**KNOXVILLE HISTORIC ZONING COMMISSION
STAFF REPORT - CERTIFICATE OF APPROPRIATENESS APPLICATION**

► FILE NO.: 20808SCN

ADDRESS OF PROPERTY: 1105 Scenic Dr

► DESCRIPTION OF WORK: Removing a rear screened porch and replacing it with a garage; removing existing garage and adding a laundry room; add covered stoop for front entry. Hardi-shake and brick veneer exterior, with asphalt roof shingles. Front porch will have swept front gable with small telescoping front gable to mark front entry, brick columns with segmental arch at front entry; tripled square columns at corner of side section of front porch.

1 FRONT ELEVATION
6 NOT TO SCALE

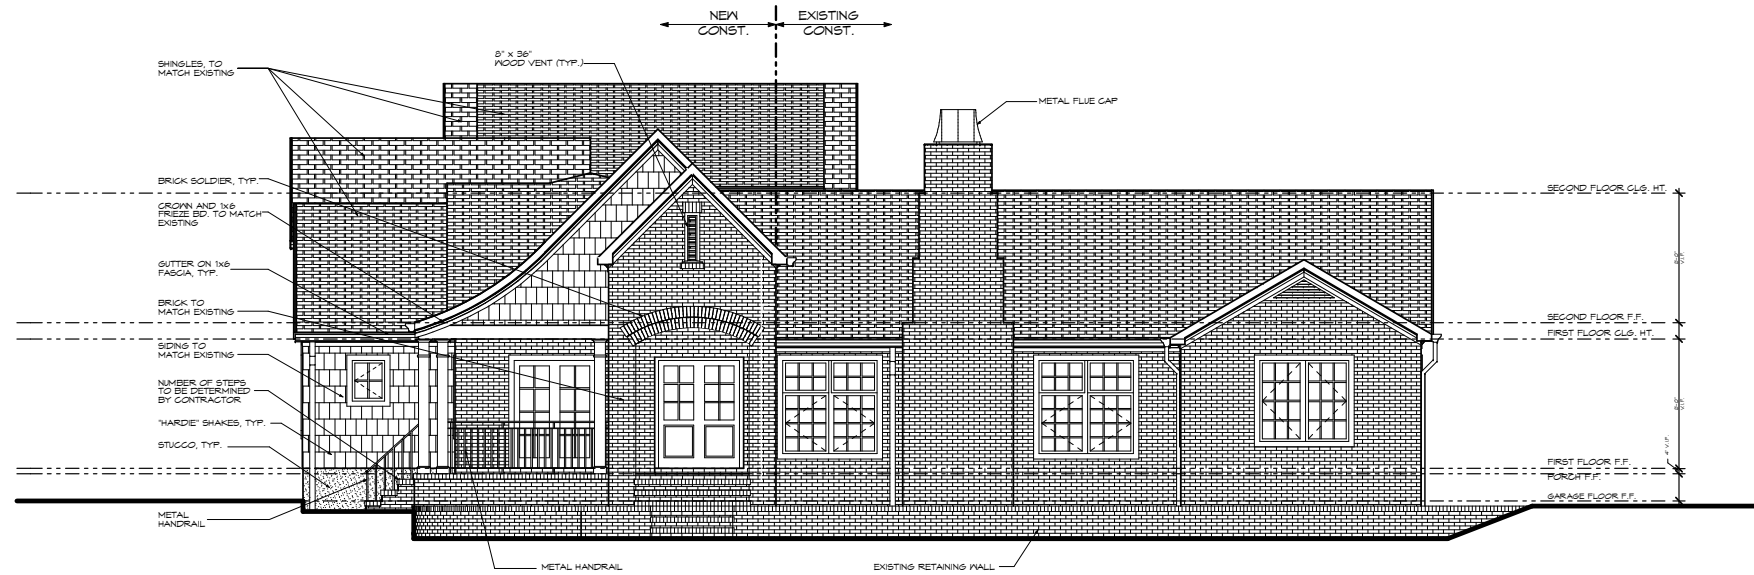
New Construction - Additions (pg. 12) calls for materials that are consistent with the existing historic materials (#12). Carports and garages should not face the street (pg. 12, #7). Under Roof (pg. 13, #1 & #2) the roof pitch and roof shape is consistent with others in the district. The proposed plans create a strong front entry orienting the house better to the street (see pg. 13, #2).

APPROVE Certificate No 20808SCN. Proposed changes will improve front façade of house so it blends better with other historic buildings on Scenic.
